# Sylmar Ground Return System

## Replacement Project

### FINAL ENVIRONMENTAL IMPACT REPORT

SCH #2010091044 | July 2016

**FIGURE 2-1 RESULTS OF GRAIN SIZE ANALYSES ALONG THE PROPOSED CABLE ROUTE**

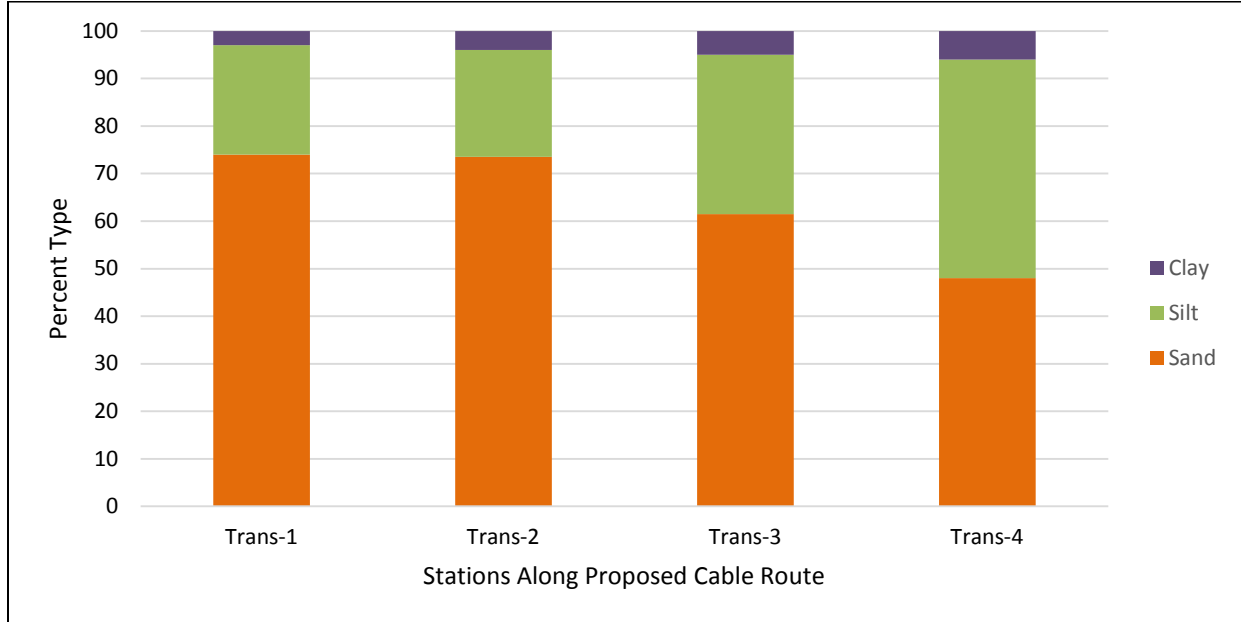
The geology and geomorphological characteristics of the ocean floor along the cable route will determine the type of sediment disturbed during the cable burial operations. Thus, the first step in understanding the potential impacts from the proposed cable laying operations for the SGRS Replacement Project was an assessment of sediment characteristics along the proposed cable route. As discussed on page 3-28 of the Draft EIR, as part of the Marine Resources Assessment conducted for the Project (Appendix D2 of the Draft EIR), samples were collected for grain size analyses at four locations along the proposed cable route (see Figure 3.3-1). Sampling locations were located along the cable route on transects positioned at the following distances from shore: 1,000 feet (Transect 1), 3,800 feet (Transect 2), 7,000 feet (Transect 3), 10,100 feet (Transect 4). Transect 4 is located adjacent to the site of the proposed electrode array for the Project.

Grain size along the proposed cable route appeared to be strongly correlated with water depth. Sediment collected from Transects 1 and 2 (25 and 40 feet deep, respectively) consisted primarily of approximately 75 percent sand and 23 percent silt. Transect 3 sediments (60 feet deep) consisted of approximately 60 percent sand and 33 percent silt, and Transect 4 (90 feet deep) sediments consisted of approximately equal amounts of sand and silt (48 percent and 46 percent, respectively). Sediments at all transects contained a small amount of clay (2 to 6 percent). Results of grain size analyses from the Marine Resources Assessment are presented by location along the cable route (Transects 1 through 4) on Figure 2-1 (from Appendix D-2 of the Draft EIR).
